CITY OF ALBUQUERQUE

Planning Department
David S. Campbell, Director

RE: **Oso Bio Syringe Line**
Grading Plan for Building Permit 4401 Alexander Blvd
Engineer's Stamp Date 6/21/2018 Disapproved
Hydrology File: F16D003B1

OSO BIO	
PROPOSED DRAINAGE MANAGEMENT PLAN	
DRAWN BY:	DATE: 06/21/2018
CHECKED BY:	PROJECT NO. 20190058 SHEET NO. 2 OF 2

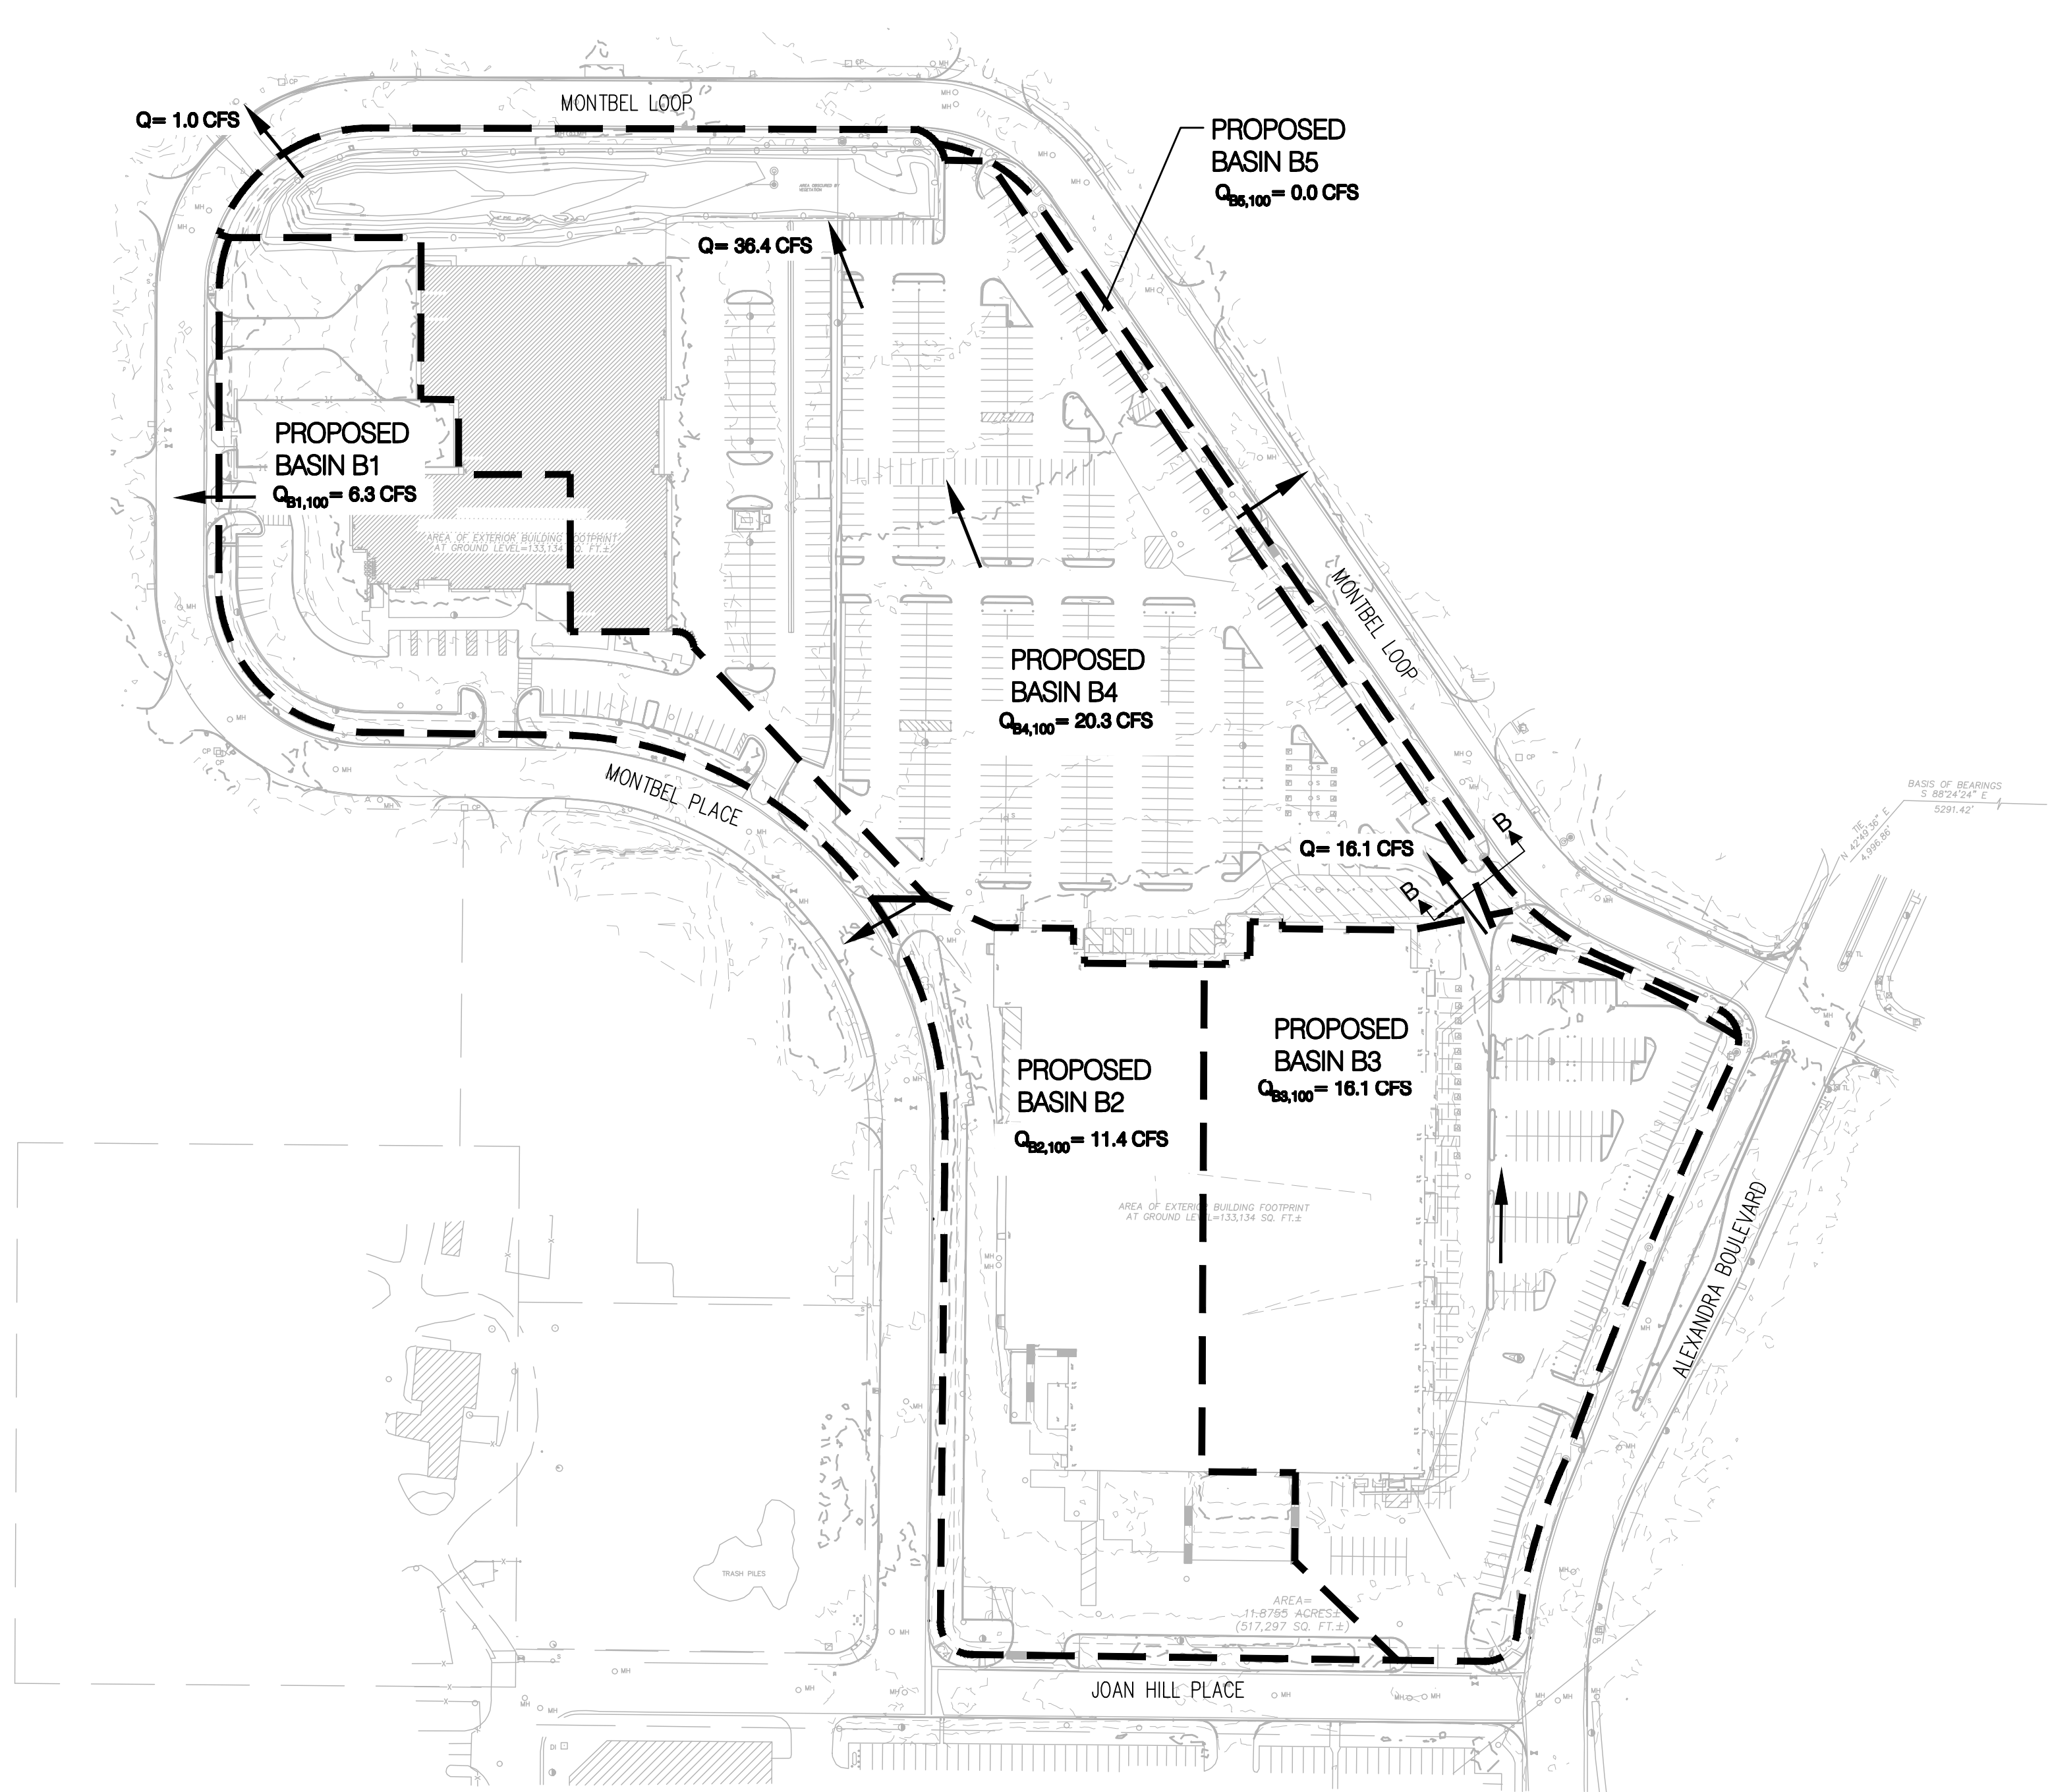
Based on the information provided in the submittal received on 6/21/2018 the above-referenced Grading Plan still does not adequately address the "Plan Check Comments" 3, 4, 5, 6, 7, 9, & 11 on the conditionally approved Grading Plan with engineer's stamp 8/29/2017 (see attached). The building permit was issued in August 2017 with the understanding that all of the conditions would be fulfilled prior to Certificate of Occupancy. DCI engineering made two additional submittals which were reviewed in December 2017 and February 2018, and this application from BHI makes the 3rd submittal since the conditions were agreed to by Oso Bio at the time the building permit was first issued.

1. All proposed grading must be shown on the grading plan including:
 - a. The closure of the unused driveways and additions of notes stating "An excavation permit will be required before beginning any work within City Right-Of-Way". Another note should state "Two working days prior to any excavation, the contractor must contact New Mexico One Call, dial "811" [or (505) 260-1990] for the location of existing utilities. Prior to construction, the contractor shall excavate and verify the locations of all obstructions. Should a conflict exist, the contractor shall notify the engineer so that the conflict can be resolved with a minimum amount of delay."

- b. The re-grading of the east driveway to prevent drainage from leaving the site,
 - c. Details of how the drainage pattern will be preserved at the west driveway when the west driveway is closed (SO-19 may be required), and

- d. Updated site layout of the Building expansion and associated grading.
2. All calculations must be presented including the newly measured pond topography and volume calculations, the outfall structure details and hydraulic calculations, and hydrology calculations in accordance with the DPM. The SCS method is not allowed in the current DPM though it is allowed in the draft revisions to the DPM. Composite CN calculations are required using the approved curve numbers in the draft DPM

and HEC-HMS model must be provided to verify use if the prescribed precipitation distribution and lag time.

3. First flush is required for redevelopment projects like this, and the conditions of approval on the 8/29/2017 plan were made assuming that the existing pond already serves that purpose in addition to providing the stormwater management required for all sites in the Renaissance Center. The pond design must demonstrate compliance with both the first flush and stormwater management requirements, and the approved pond design must be clearly shown on Exhibit 'A' to the drainage covenant with the design volumes and outlet structure size clearly labeled. The exhibit may be on several sheets. The drainage covenant must be signed by the "owner" of the property that the pond is located on, Tract A. If a separate agreement between the two property owners, Tract A and Tract B, is required by the owner of Tract A, the City does not need to be a party to that agreement. The owner's signatures must be notarized and the original document together with a \$25 check payable to the Bernalillo County must be submitted to Madeline Carruthers on the 4th floor.
